## **Proposal for Supplement 1 to the 03 series of amendments to UN Regulation No. 58 (Rear underrun protection devices)**

### **Submitted by the experts from the Working Party on General Safety\***

## Supplement 1 to the 03 series of amendments to UN Regulation No. 58 (Rear underrun protection devices)

Figure 1

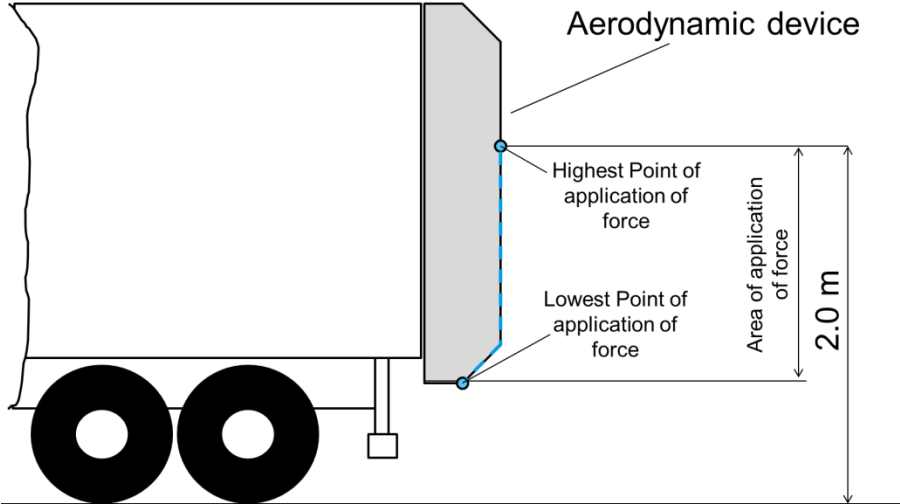
- 5.1.1. A force shall be applied parallel to the longitudinal axis of the vehicle via a surface not more than 250 mm in height and 200 mm wide with a radius of curvature of  $5 \pm 1$  mm at the vertical edges or an adaptor. The surface or adaptor shall not be rigidly fixed to the aerodynamic device and shall be articulated in all directions. When the test is carried out on a vehicle the height of the centre of the surface or adaptor shall be defined by the manufacturer in an area between the lowest edge of the aerodynamic device and a point no more than 2.0 meters above the ground in vehicle-mounted condition (see figure 1). This point is to be defined on a laden vehicle with the technically permissible maximum laden mass.

Figure 2

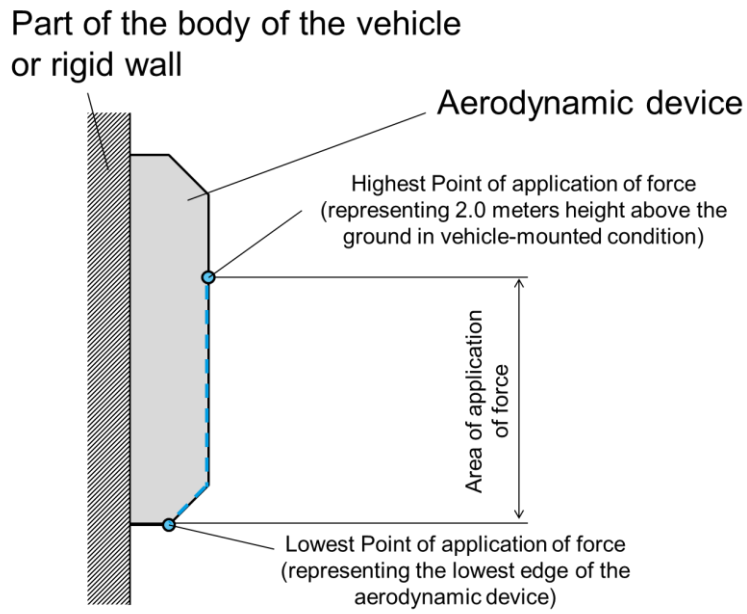
When the test is carried out on a part of the body of the vehicle type or on a rigid wall the height of the centre of the surface or adaptor shall be defined by the

manufacturer in an area between the lowest edge of the aerodynamic device and the point that represents the height of no more than 2.0 meters above the ground in vehicle-mounted condition on a laden vehicle with the technically permissible maximum laden mass (see figure 2).

Figure 3

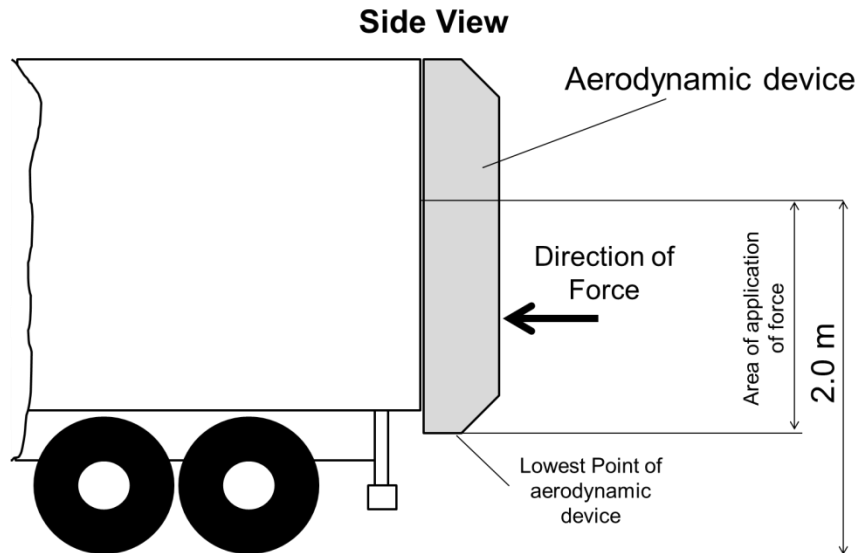
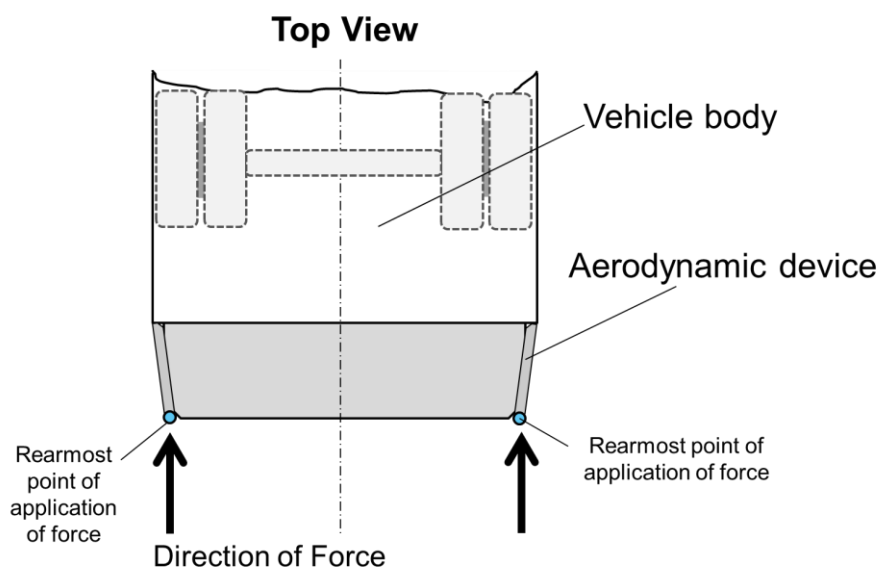
5.1.2. A horizontal force of maximum  $4000\text{ N} \pm 400\text{ N}$  shall be applied consecutively to two points situated symmetrically about the centre line of the vehicle or the centre line of the device on the rearmost outer edge of the aerodynamic device in completely unfolded or not retracted condition (see figure 3). The order in which the forces are applied may be specified by the manufacturer.

Figure 4

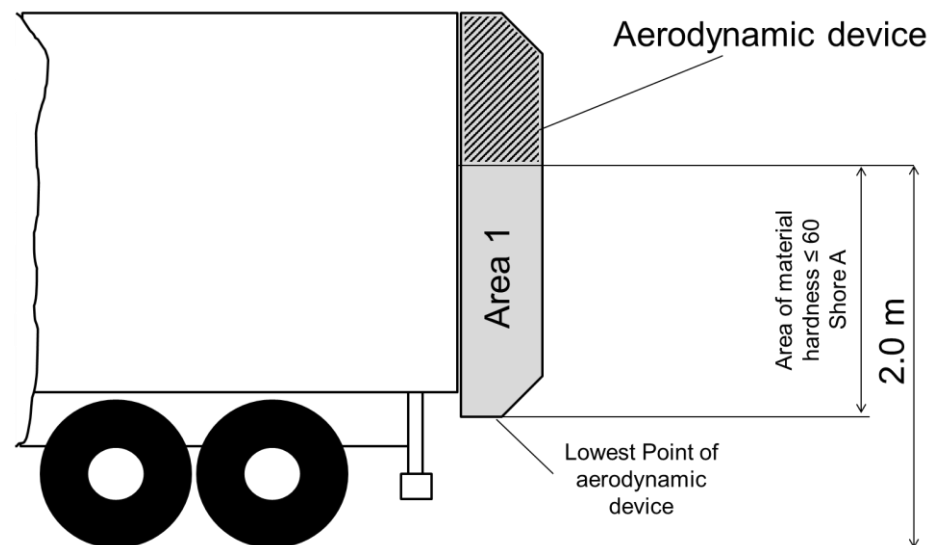
- 6.2. Notwithstanding the provisions in paragraph 5.1., 5.1.1., 5.1.2. and 6.1. the application of forces shall not be conducted if the aerodynamic device is made of a material of hardness not exceeding 60 shore A in the area 1 regarding figure 4. Components (fastenings, hinges, actuators, springs, cables, lamps, etc.) used to install the aerodynamic device on the body of the vehicle or that are mounted on the aerodynamic device are exempted from these provisions.
